Route 1 Multimodal Improvements – Northern Virginia District

Livability22202 Meeting

February 22, 7:00 pm to 9:00 pm

Other Alternatives

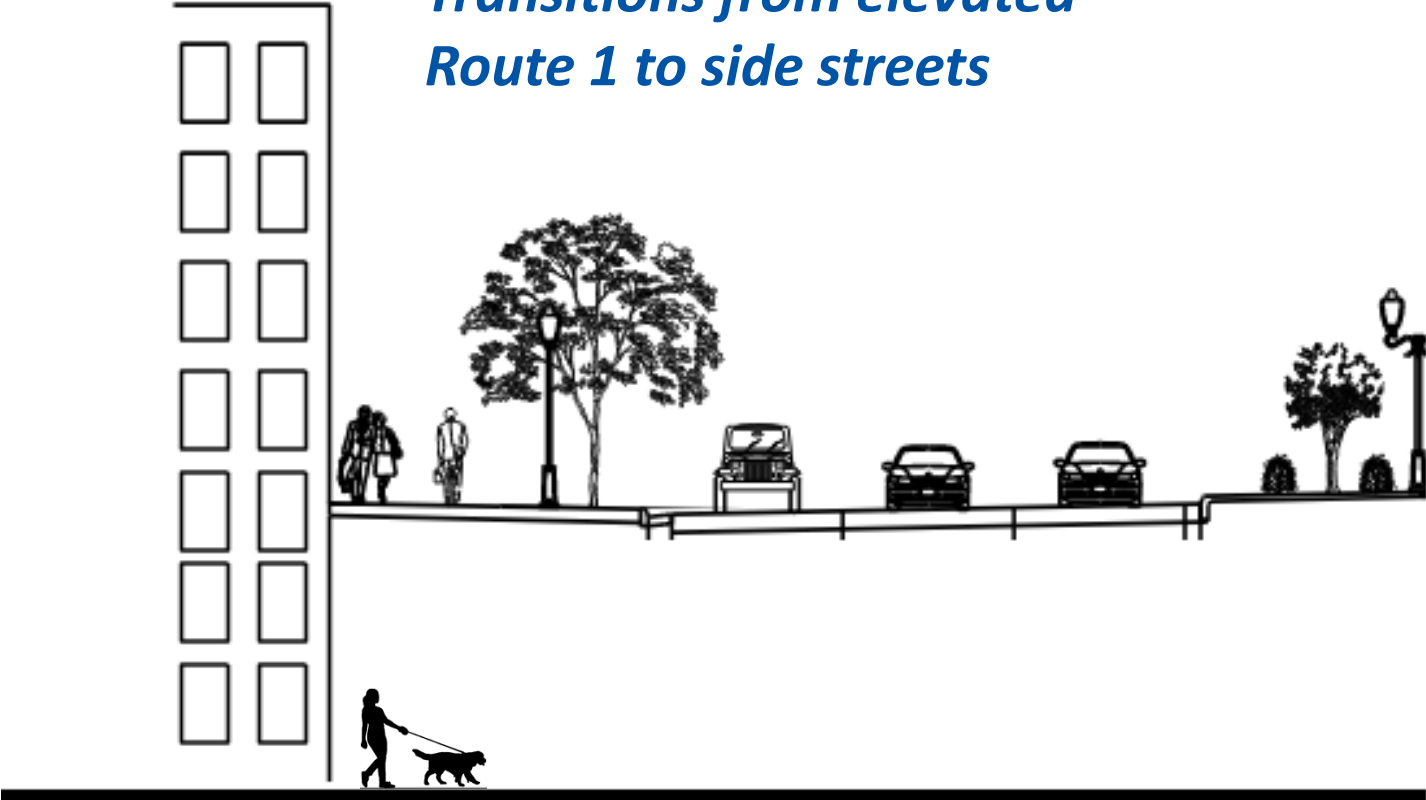
- Consider a linear park in the median. Could increase crossing times, but may be worth the extra wait if access is provided parallel to Route 1.

- A linear park on Route 1 in the middle of a 45,000 vpd roadway would not be a welcoming space.
- Adding a median park runs counter to current trends in 22202.
- A linear park would only be feasible in the at-grade option.
